Application Number	19/01597/AS	
Location	Home Plus, Beaver Road, Ashford, Kent, TN23 7RR	
Grid Reference	Easting 601063 Northing 142081	
Parish Council	No Parish Council	
Ward	Victoria	
Application Description	The erection of 216 residential units comprising 207 apartments and 9 townhouses (C3) and commercial floorspace comprising 3 commercial units (Units A, B and C) for a flexible range of uses (A1, A3, A4, A5, B1, D1 and D2) and roof top restaurant, with associated access and landscaping..	
Applicant	A Better Choice for Property Developments	
Agent	Emma Hawkes – DHA Planning	
Site Area	9093 sqm	
(a) 7/4R	(b) -	(c) KCCH&T-X

Introduction

1. At the Planning Committee held on the 9th December 2020, Members resolved to defer the consideration of the application for the following reasons:

Figure 2 - Beaver Road Elevation (West)

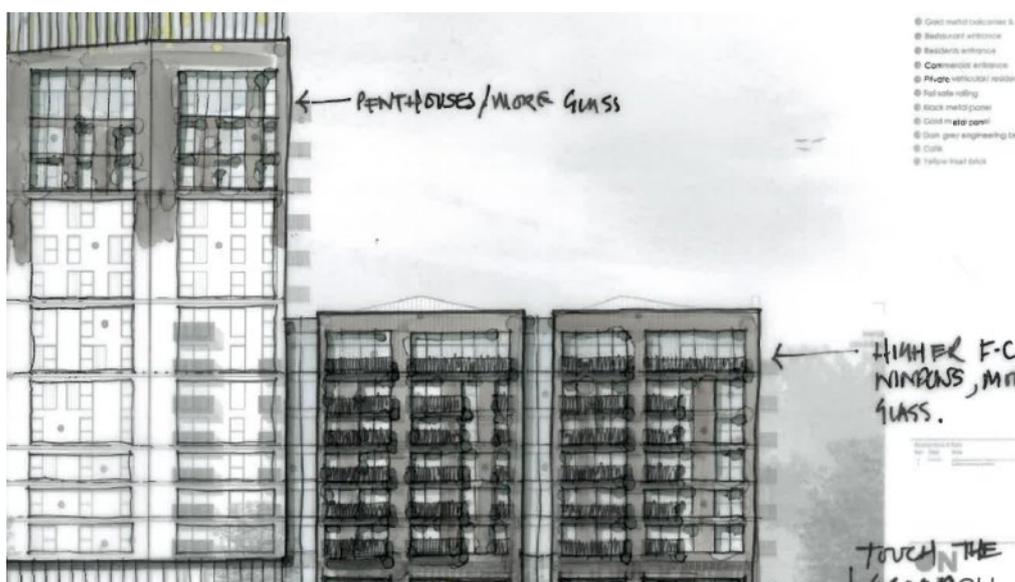
- *Increased the window aperture sizes to the top section of the tower and more glazing added to introduce a more 'loft / penthouse' feel to the scheme adding a greater choice of unit types for the end user.*
- *Removed the metal cladding to the plinth section of building.*
- *Removed the pitched roof design.*
- *Increased the amount of glazing to the upper units with increased floor to ceiling heights. Adding to an alternative mix of unit types.*
- *Taken the brick work façade to the floor, thus grounding the residential element above. This also create diversity of commercial unit types to the lowest two floors.*

Figure 36- *Illustration of where building has increased and decreased in height, alterations to architectural language of façades and how this emphasises different vertical characteristics*

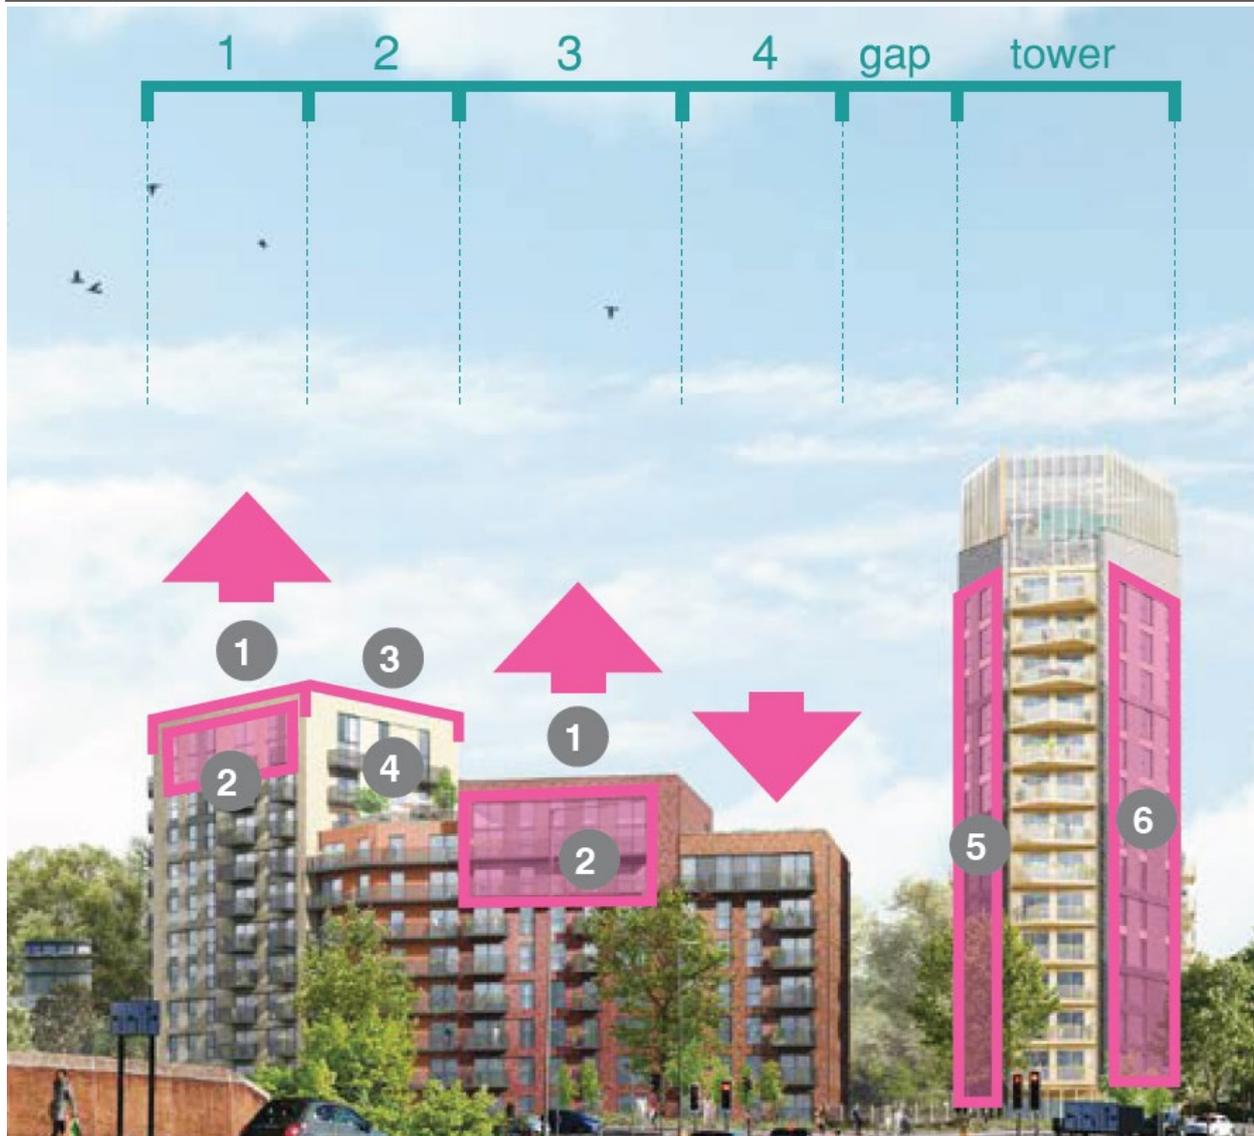
55. I support these design changes since they achieve a better defined overall architectural style for the building, by emphasising clear contrast for the tower in relation to lower buildings around it. Overall though there is still a complementary architectural language that design review panel workshop suggested might by an effective way of responding to members concerns. I support these particular changes to the design.
56. In response to members concerns about the main facades the design panel workshop session put forward the idea of dividing up the proposed frontages of the lower surrounding blocks to the tower to introduce a stronger vertical emphasis. The design changes have addressed this through increase in height in some places and slight reduction in others, in order to create clearer definition to each section of the building.

57. I consider the design amendments achieve these objectives and overall I am very satisfied with the way the design amendments attempts to break up the horizontal form, with interesting setbacks and contrasting materials and detailing to facade. I support these changes to the elevations and do not recommend any further changes to the design on these grounds.
58. To try and breaking up the form and massing required by members, the design review panel workshop advocated introducing a mix of housing typologies to upper floors to create more variety internally that could be expressed externally in the built form, massing and architectural expression. The proposals now include some larger and more generous penthouse apartments on the top floors.

Figure 40 – The proposal varied roof form in relation to local context.

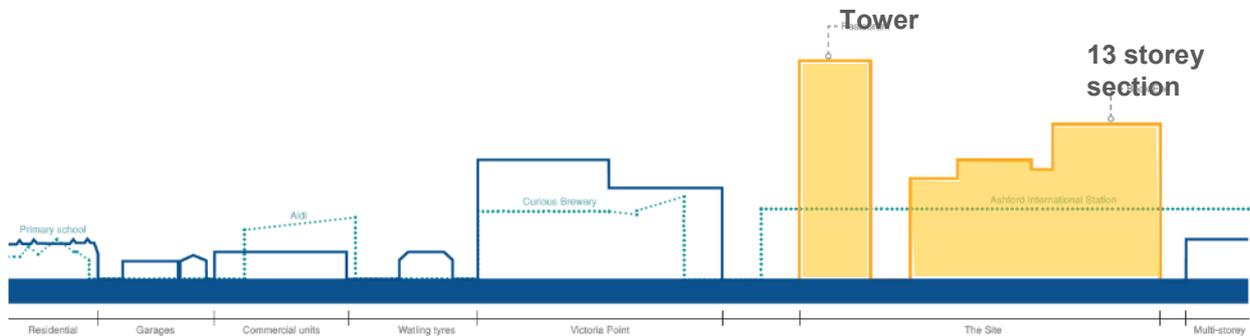
59. The proposed inclusion of top floor penthouses would result in more obvious variety to the external appearance. This is achieved by introducing some more generous internal floor to ceiling heights which has created an opportunity to create different roof eaves and parapet levels which are more pronounced and noticeable.

60. This adds further richness to the proposed building and adds further distinctiveness and interest to the skyline in this part of the town centre. On these grounds I consider the amendments have responded positively to the concerns of the Planning Committee, and have listened to the advice provide at Design Review panel workshop and I support these design amendments to the form of the building.

Figure 46 *Riverside South Elevation (2020 Superseded)*

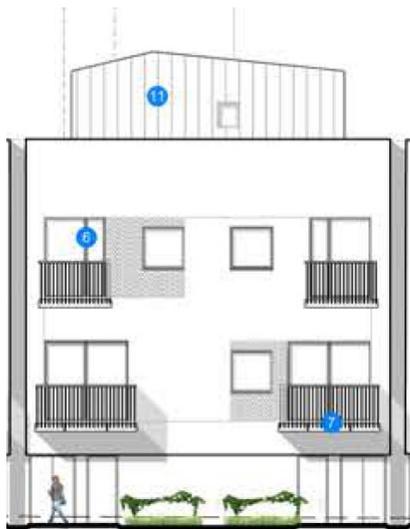
61. In response to improve the overall form and appearance of the buildings that members were concerned by, the design panel workshop recommended that key openings and larger windows could become compositional devices that could be expressed more playfully on the façade. As the comparison images of the amended detail demonstrate below, the external elevations would result in a more distinctive mix of different sized window forms that is enhanced by the combination and subtle mix of materials.

Figure 58 – Main Materials – Yellow buff

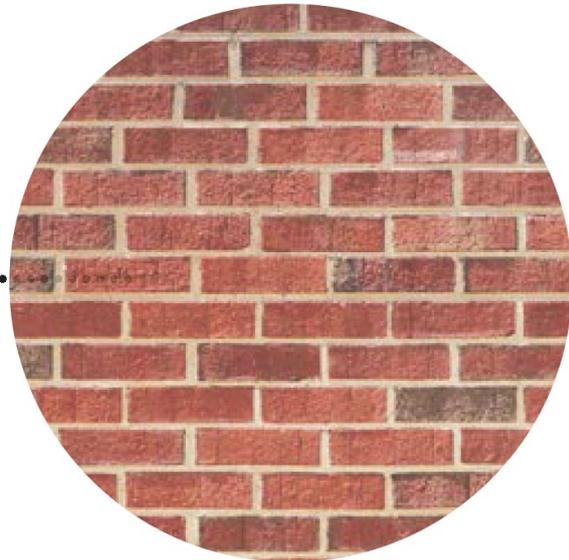
94. The amended scheme has responded to advice offered at the design review workshop who did not agree with the arbitrary application of the green 'weathered copper' colour metal cladding on the most eastern building block facing Avenue Jacques Faucheux. The panel suggested members were more likely to be more comfortable with high quality brickwork embellished with complementary high quality materials. In direct response to this, the scheme has been amended to more brick on this end building and I support that revision.

100. Therefore should the scheme be supported, I recommend that a small group consisting of an officer and a Planning Committee member could form a materials selection working group with the applicants, to help agree the main final external specifications of materials on the building at the conditions approval stage. I have agreed this approach in principle with the applicant.
